ADDENDUM No. 1 – March 25, 2026

DATE: 03/23/26
DRAWING NUMBER:
ADD-01
A-001

PROJECT TITLE:
Tufts Vet Tech Clinic Renovation
Worcester Technical High School
1 Officer Manny Familia Way, Worcester, MA 01605

Additional Power
and Data Demolition

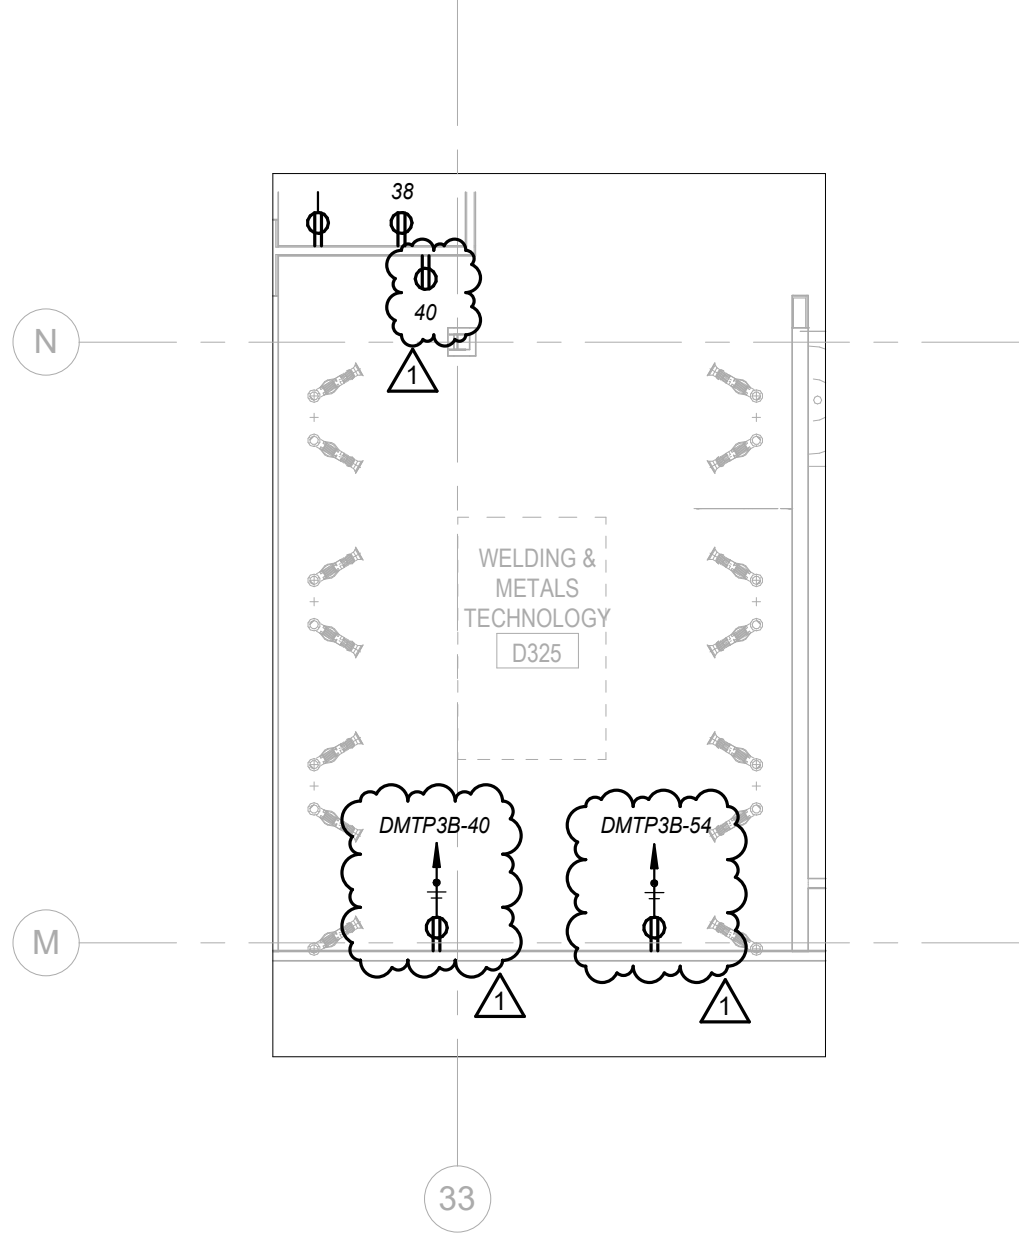
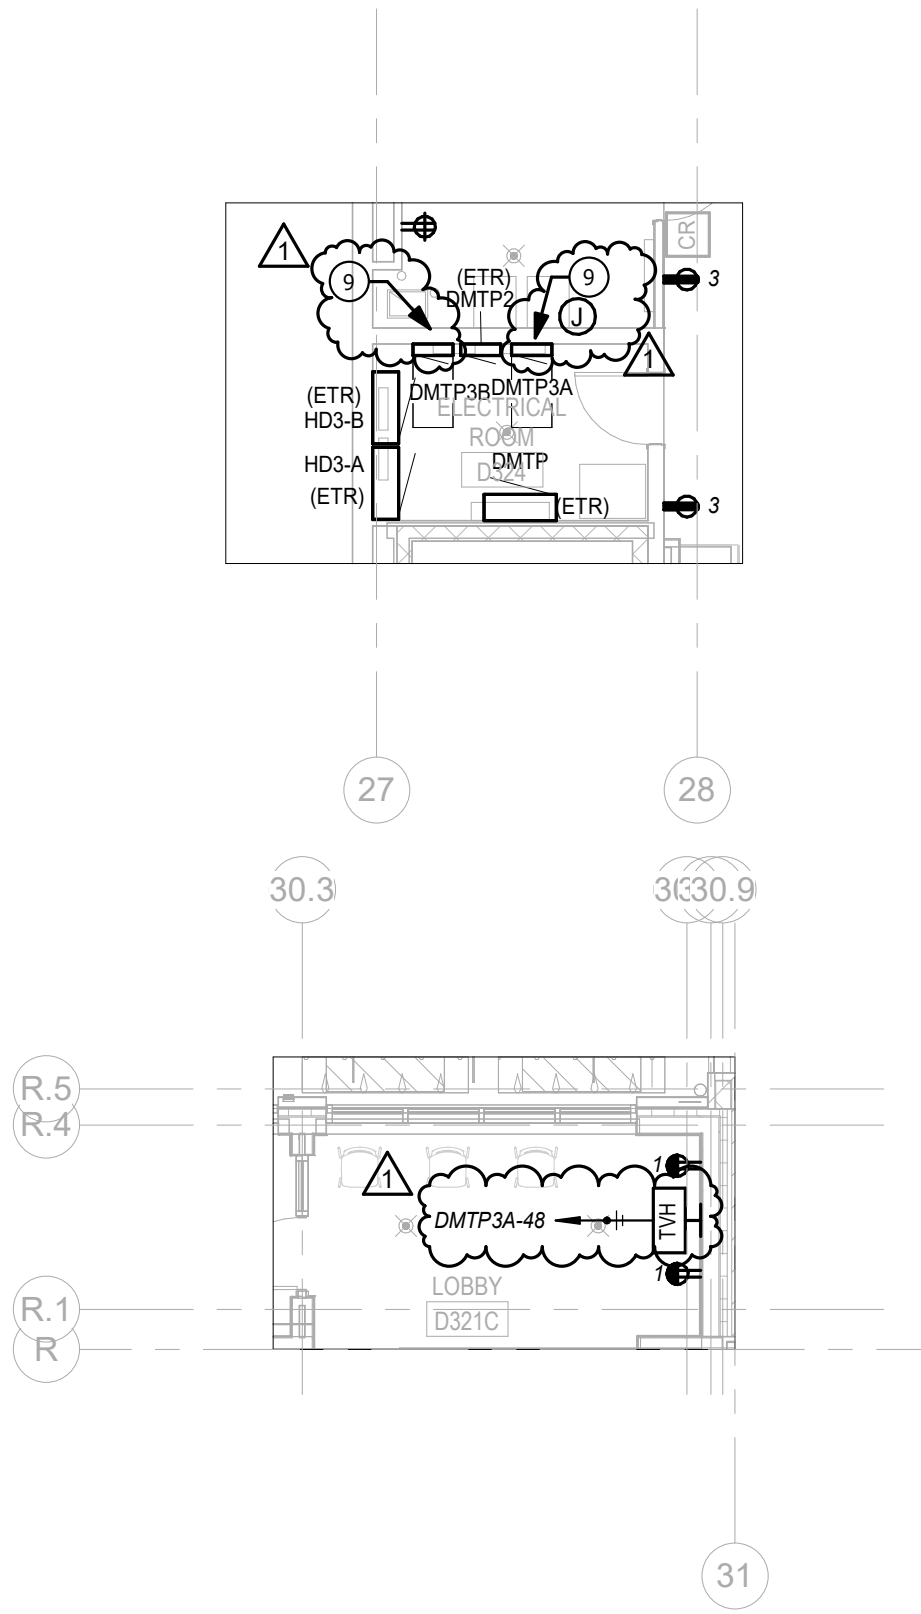
- A. Add (2) receptacles for demolition
- B. Add (2) data outlet for demolition
- C. Add (1) junction box for demolition
- D. Refer to ADD-1/E-001

Additional Power

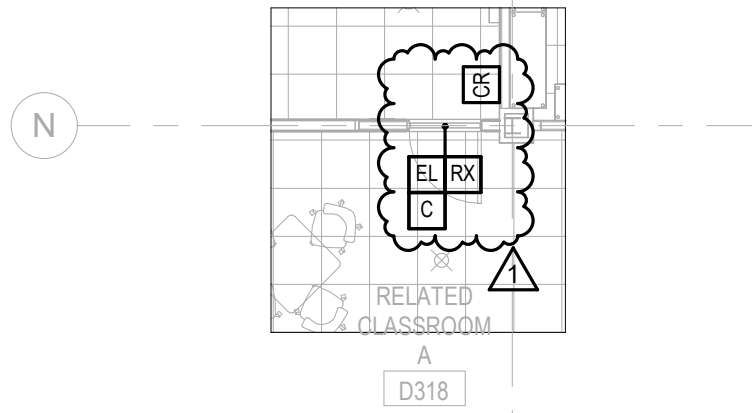
- A. Lobby D321C – Add (1) TVH on north wall.
- B. Welding Booths – Add (2) duplex receptacles on east wall and (1) duplex receptacle on west wall. Connect new receptacles to (2) dedicated circuits DMTP3B-40 and DMTP3B-54
- C. Add keynote #9 for plywood backboard
- D. Refer to sketch ADD-1/E-002

WPS - Security Plan

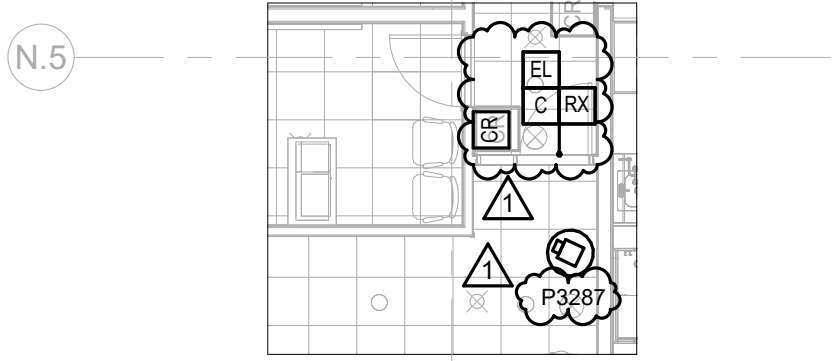
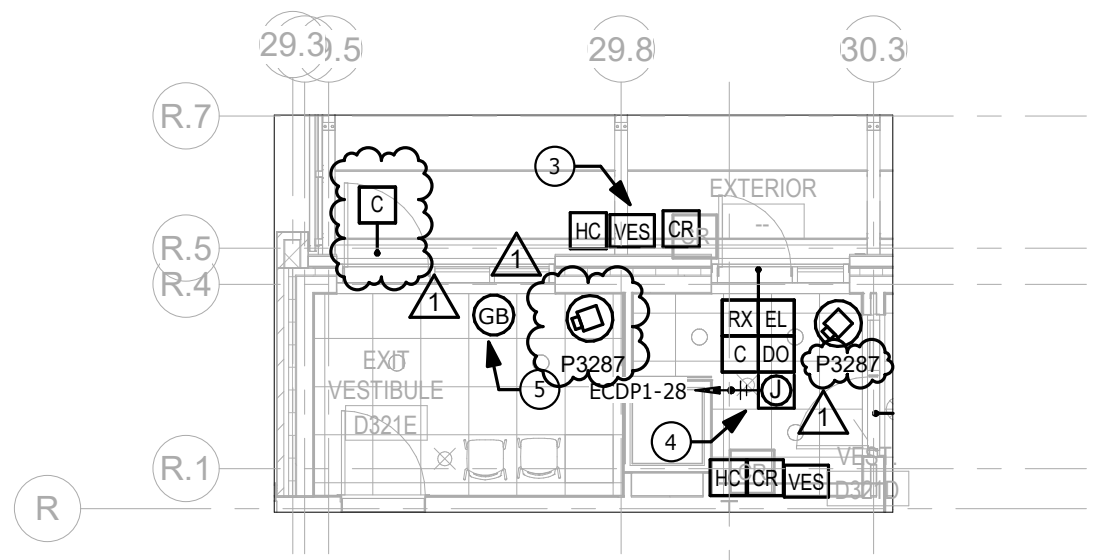
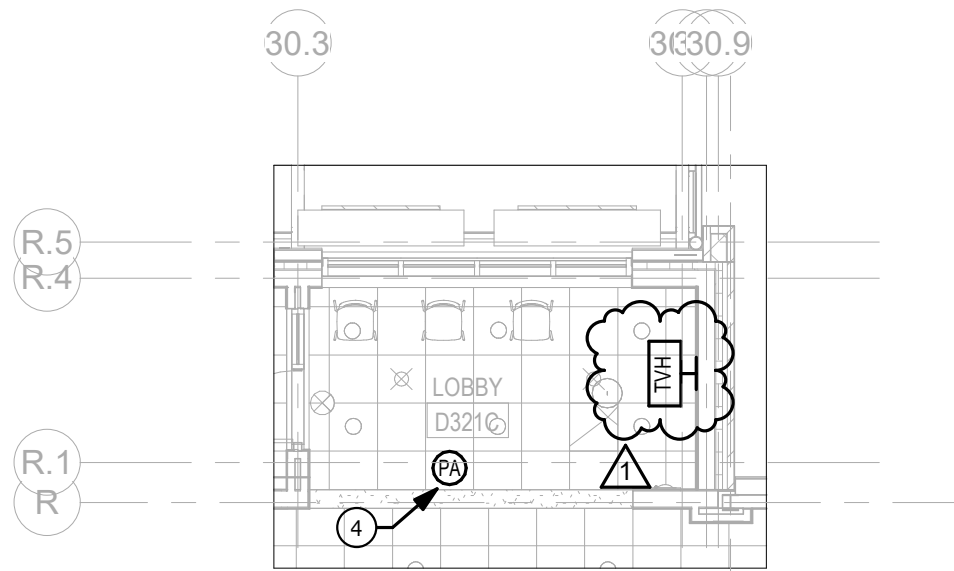
- A. Vestibule D321E: Add (1) door contact, and (1) P3287 camera
- B. Vestibule D321D: Revise camera tag to read "P3287"
- C. Student Corridor D317: Revise camera tag to read "P3287". Moved card reader for corridor door from Tufts' scope to WPS' scope.

- D. Day Boarding Room D321A: Add (1) card reader
- E. Refer to sketch ADD-1/E-003

REFERENCE: TC1.1
DRAWING TITLE: WPS - Technology Plan

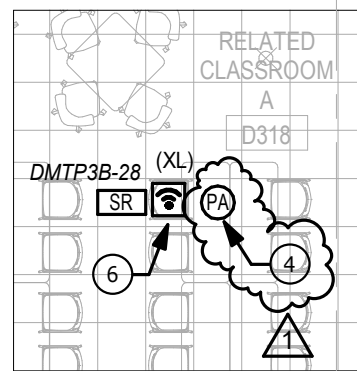
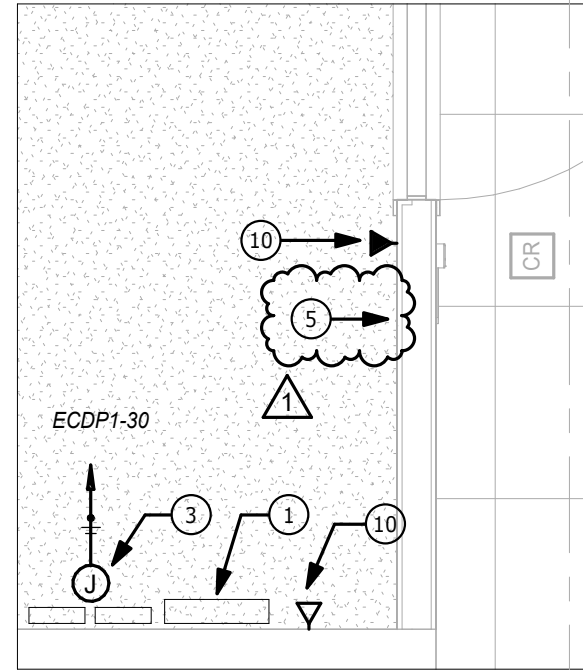
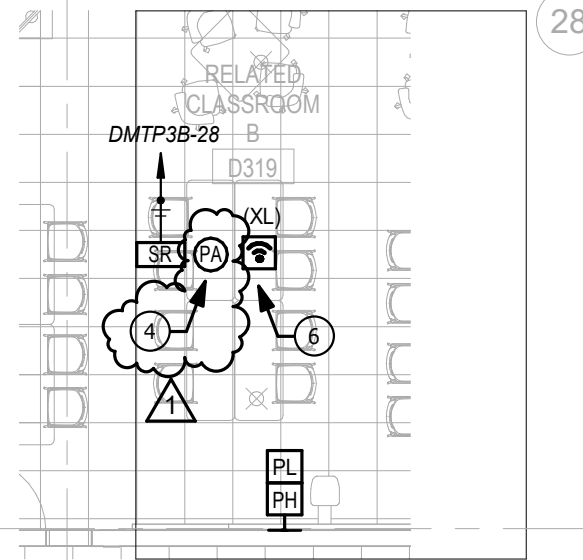
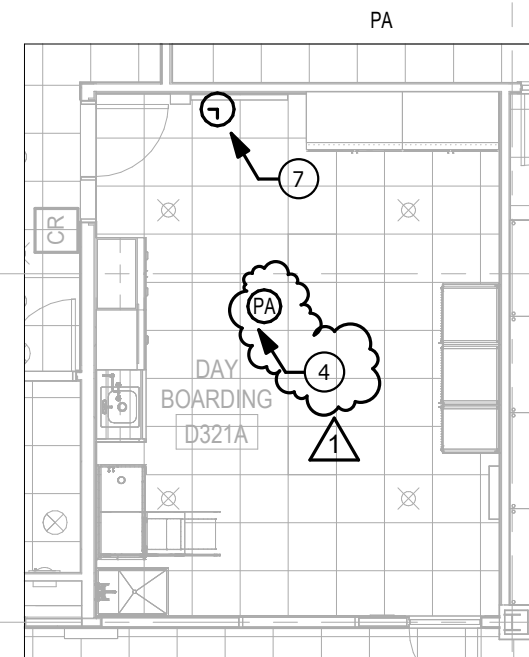
- A. Classroom A D318: Change TB to PA speaker
- B. Classroom B D319: Change TB to PA speaker
- C. Day Boarding Room D321A: Change TB to PA speaker
- D. IDF D319A: Add keynote #5 to read “WRAP THE ROOM WITH 8'H X 4'W X 3/4"D FIRE RATED PLYWOOD.”
- E. Refer to sketch ADD-1/E-004

KEYED NOTES FOR TC1.1
5 WRAP THE ROOM WITH 8'H X 4'W X 3/4"D FIRE RATED PLYWOOD.

ADD1
E-006

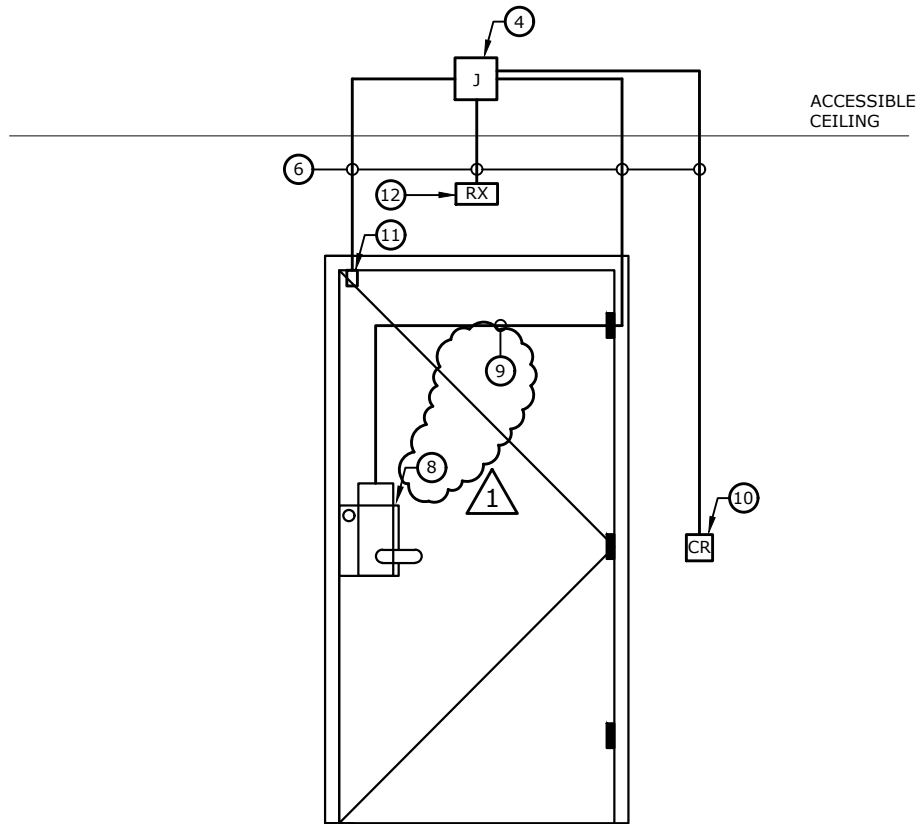
- A. Remove “TB” symbol and description.
- B. Revise description for “PA”
- C. Add clock and description
- D. Revised description for “TVHL”
- E. Refer to sketch ADD-1/E-006

Tufts' Door Detail

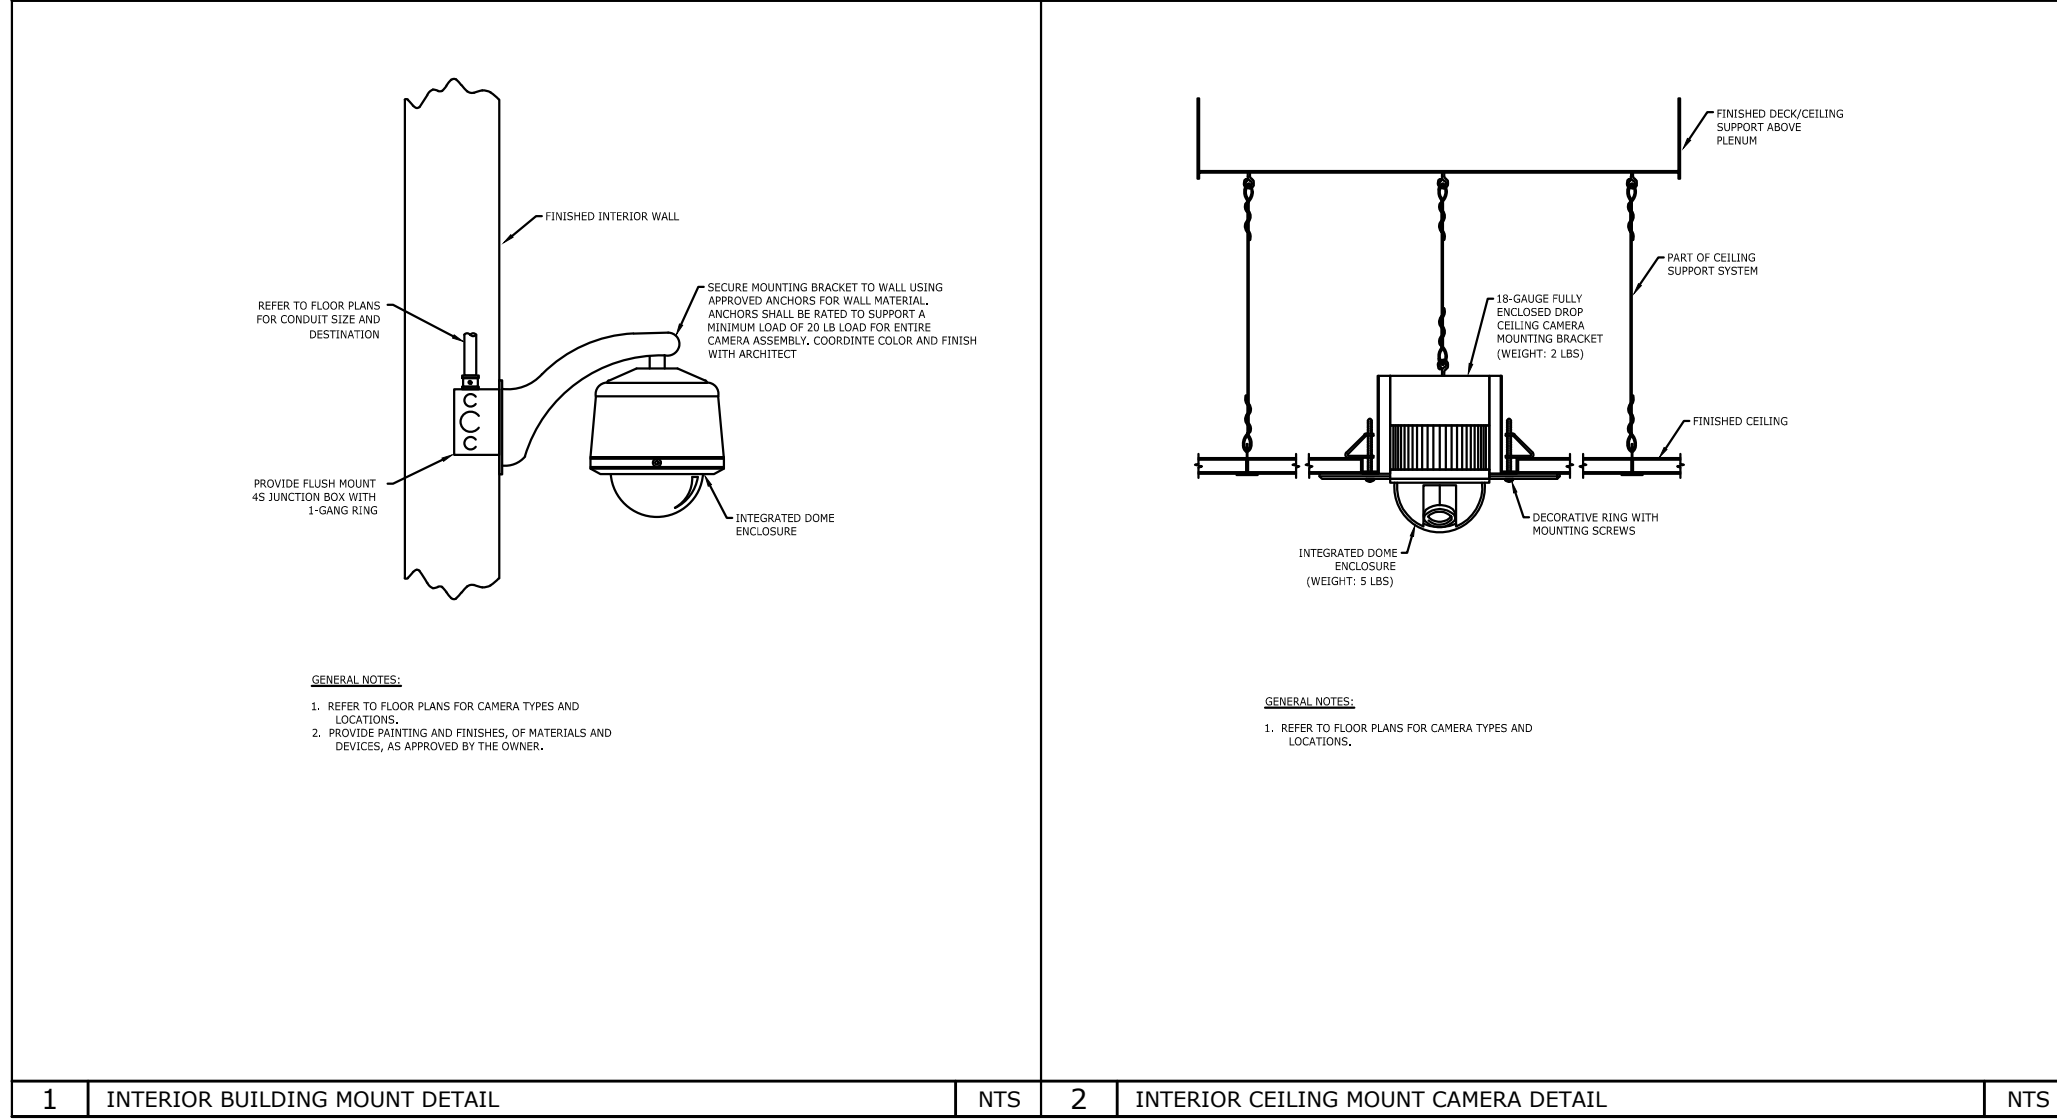
- A. Detail 5: Revise keyed note # 13 to #9, revise #14 to #8. Remove keyed note #13 & #14 from “DOOR HARDWARE WIRING NOTES”
- B. Refer to sketch ADD-1/E-007
